## Access Compliance Report Public Rights-of-Way (Curb Ramps)

Intersection ID: 30575 Main Street: CIRCLEGREEN\_DR Cross Street: GROVE\_CREK\_LN Location: NW
ADA ID: 5150284FC669 Ramp Type: PerpDiag Initial Pass/Fail: Fail Overall Compliance: No Severity Score: 1.25

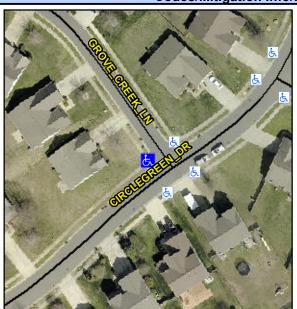
Compliance Description Date		Data	Compliance Description		Data
N/A	Ramp Length (in)	94.0	Yes	Ramp Slope (%)	7.0
Yes	Ramp Width (in)	48.0	No	Ramp XSlope (%)	3.3
N/A	Flare Type LT	N/A	N/A	Flare Type RT	N/A
N/A	Flare Slope LT (%)	N/A	N/A	Flare Slope RT (%)	N/A
N/A	Flare Traversable LT?	N/A	N/A	Flare Traversable RT?	N/A
N/A	Landing Length (in)	N/A	N/A	DWS Provided?	N/A
N/A	Landing Width (in)	N/A	N/A	DWS Contrast?	N/A
N/A	Landing Slope (%)	N/A	N/A	DWS Length (in)	N/A
N/A	Landing X Slope (%)	N/A	N/A	DWS Full Width?	N/A
N/A	Landing Curb? (Y/N)	N/A	N/A	DWS Offset (in)	N/A
N/A	Shared Landing?	N/A			
N/A	Gutter Ponding?	N/A	N/A	Gutter Slope (%)	N/A
N/A	Gutter Lip Ht (in)	N/A	N/A	Gutter X Slope (%)	N/A
N/A	Painted X Walk1?	No	N/A	Painted X Walk2?	No
	X Walk 1 Direction	To SE		X Walk 2 Direction	To NE
N/A	X Walk 1 Width (in)	N/A	N/A	X Walk 2 Width (in)	N/A
	X Walk 1 Slope (%)	1.1		X Walk 2 Slope (%)	0.9
	X Walk 1 X Slope (%)	1.8		X Walk 2 X Slope (%)	3.4

Remove & Replace Curb Ramp With Two New Directional Ramps or Equivalent.

R304.5.3
